FINAL EXPRESS TERMS

DEPARTMENT OF HOUSING AND COMMUNITY DEVELOPMENT

REGARDING PROPOSED CHANGES TO THE 2007 CALIFORNIA BUILDING CODE (CBC)

(HCD 02/07)

FIGURE 11A-6A—WARNING STRIPING AND HANDRAIL EXTENSIONS

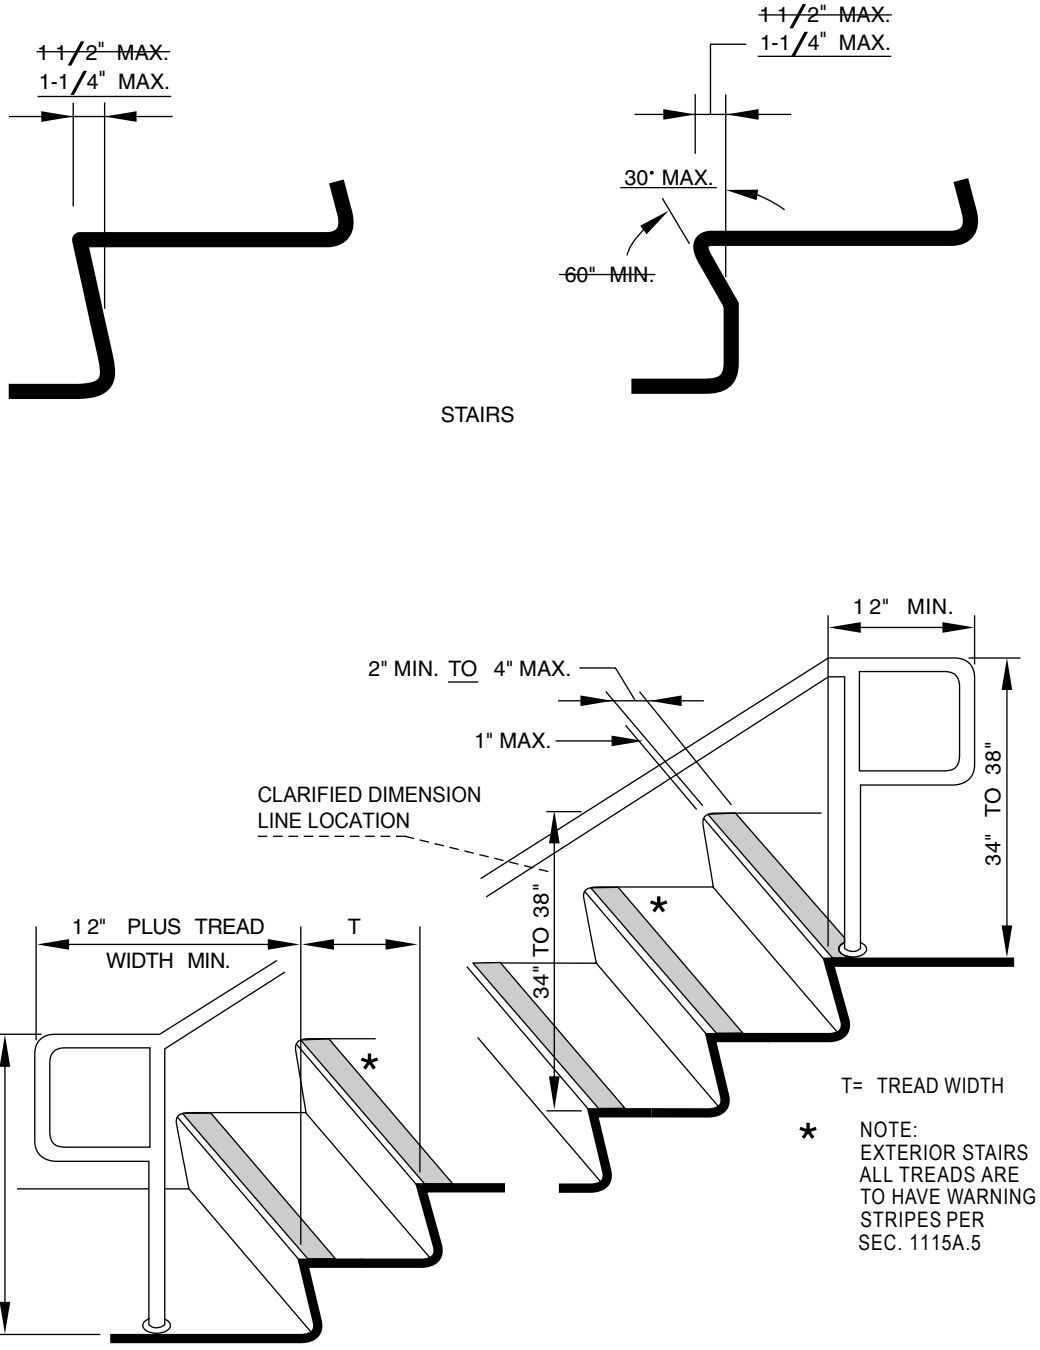
1115A.4 Nosing. *Nosing shall not project more than ~~1 ½~~ 1¼ inches (~~38.1~~ 31.8 mm) past the face of the riser below. Risers shall be sloped or the underside of the nosing shall have an angle not ~~less~~ more than ~~60~~ 30 degrees (0.52 rad) from the ~~horizontal~~ vertical. (See Figure 11A-6A).*

1123A.4 Nosing. *Nosing shall not project more than ~~1½~~ 1¼ inches (~~38.1~~ 31.8 mm) past the face of the riser below. Risers shall be sloped or the underside of the nosing shall have an angle not ~~less~~ more than ~~60~~ 30 degrees (0.52 rad) from the ~~horizontal~~ vertical. (See Figure 11A-6A).*

1123A.6.2.3 Handrail extension. *Handrails shall extend a minimum of 12 inches (305 mm) beyond the top nosing and 12 inches (305 mm), plus the tread width, beyond the bottom nosing. Where the extension creates a hazard, the termination of the extension shall be rounded or returned smoothly to floor, wall or post. Where the stairs are continuous from landing to landing, the inner rail shall be continuous and need not extend out into the landing. (See Figures 11A-6A and 11A-6E).*

33. Amend Figure 11A-6A "WARNING STRIPING AND HANDRAIL EXTENSIONS":

FIGURE 11A-8J – PLATFORM AT SECONDARY EXTERIOR DOOR

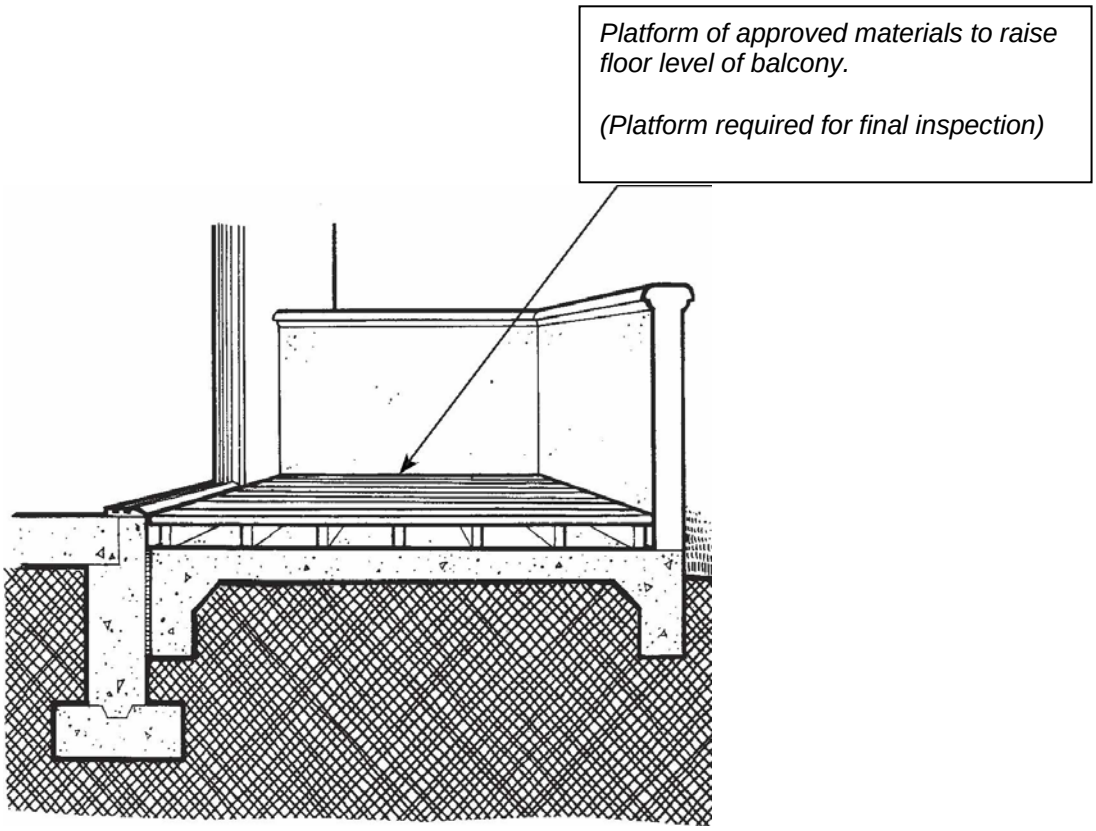
3. Secondary exterior doors onto decks, patios or balcony surfaces constructed of impervious materials (e.g., concrete, brick, flagstone) may have a maximum change in height from the interior landing of 4 inches (101.6 mm). Changes in height greater than ½ inch (12.7 mm) shall be accomplished by means of a ramp complying with Section 1114A or by means of a platform constructed to the level of the floor as illustrated in Figure 11A-8J.

Figures 11A-8J "Platform at Secondary Exterior Door"; 11A-8K "Ramp at Secondary Exterior Door"; 11A-9L "Shower with Water Closet"; and 11A-9M "Wing Wall or Cabinet at Water Closet" are added (see attached.)

FIGURE 11A-8K – RAMP AT SECONDARY EXTERIOR DOOR

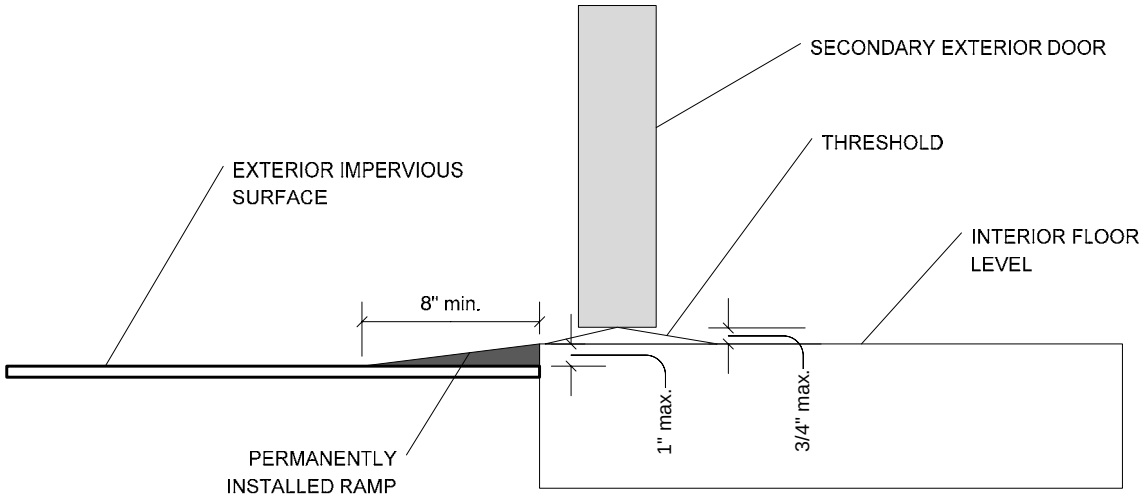
4. Secondary exterior doors onto decks, patios or balcony surfaces constructed of impervious materials (e.g., concrete, brick, flagstone) may have a maximum change in height from the interior landing of 1 inch (25.4 mm), provided a ramp with a maximum slope of 1:8 is permanently installed. (See Figure 11A-8K.)

FIGURE 11A-9L – SHOWER WITH WATER CLOSET

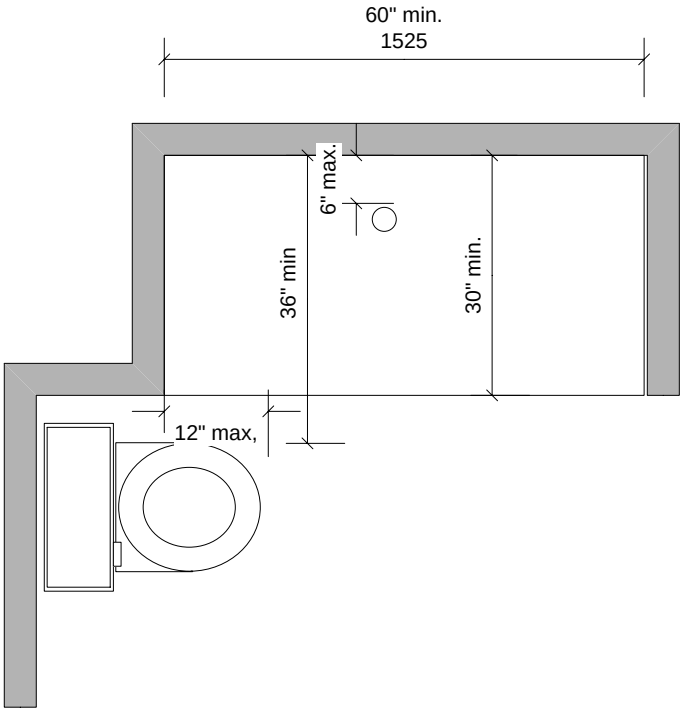
1.2 The shower stall shall measure at least 30 inches deep by 60 inches wide (762 mm by 1524 mm) with an entrance opening of at least 60 inches (1524 mm). A water closet may project a maximum of 12 inches (305 mm) into the opening provided that a minimum of 36 inches (914 mm) clear space is maintained between the water closet and the shower wall as illustrated in Figure 11A-9L or;

FIGURE 11A-9M – WING WALL OR CABINET AT WATER CLOSET

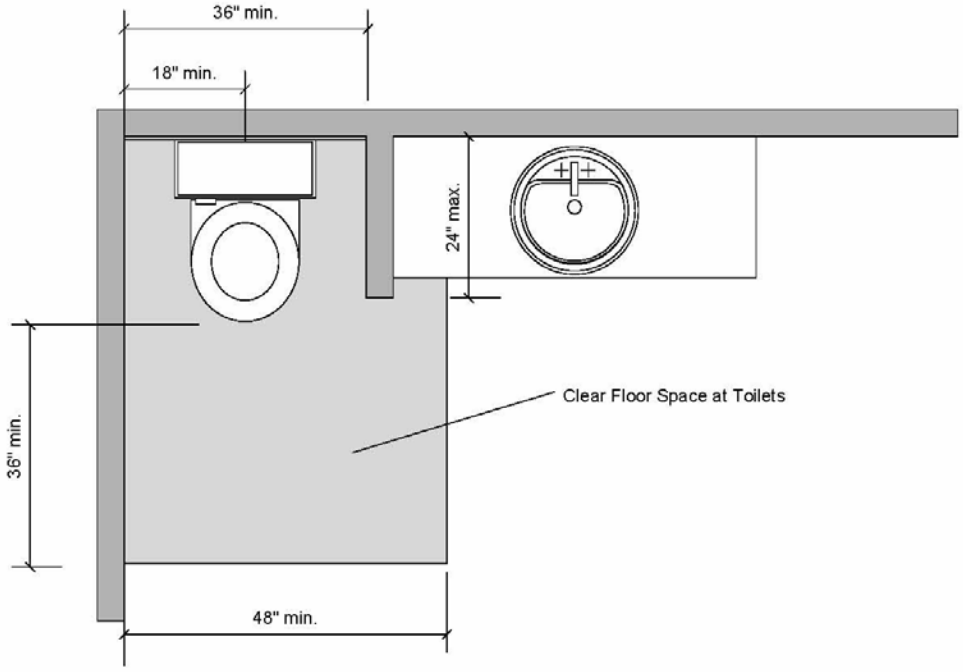
1. ***Floor Space.*** *~~The water closet shall be located in a space a minimum of 36 inches (914 mm) in clear width with 48 inches (1219 mm) minimum clear space provided in front of the water closet. This space may include maneuverable space under a lavatory, if provided and arranged so as not to impede access.~~ The minimum floor space provided at a water closet shall be 48 inches (1219 mm) in clear width. The clear floor space shall extend past the front edge of the water closet at least 36 inches (914 mm). See Figure 11A-9M.*
